Joe Capowski to the CH Town Council on Duke Power wiring March 25, 2002

ATTACHMENT 2

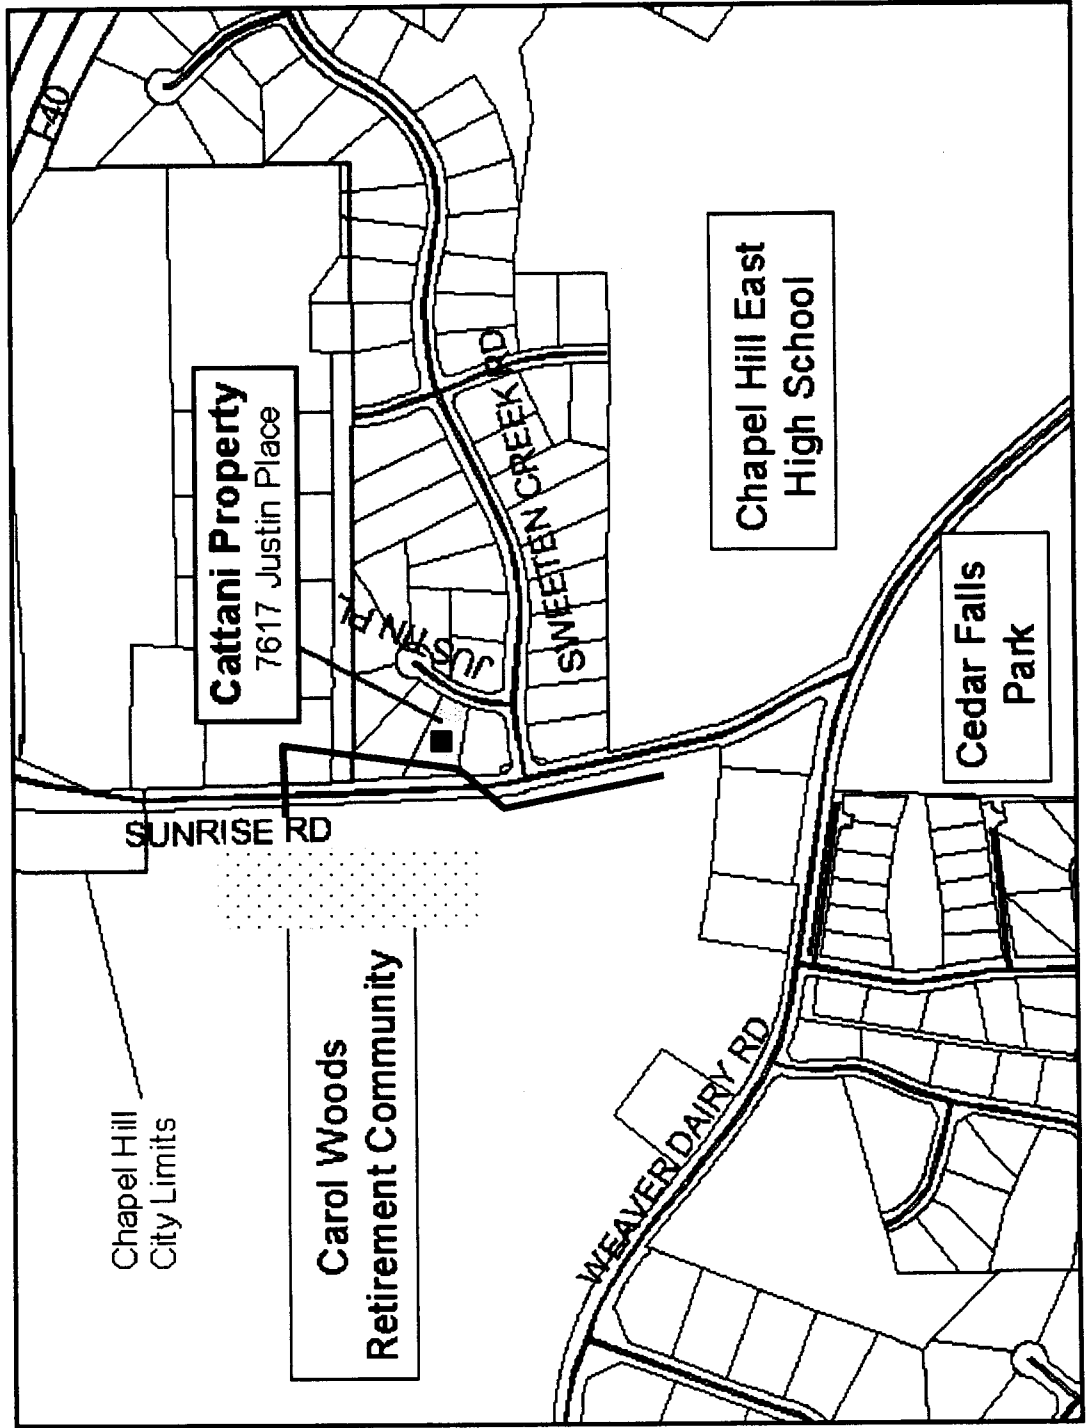
Duke shows that the danger in the Carol Woods case does not justify concrete encasement, for they bury the same 3-phase lines without concrete encasement that they say they must encase in concrete off a customers property. -- show photo
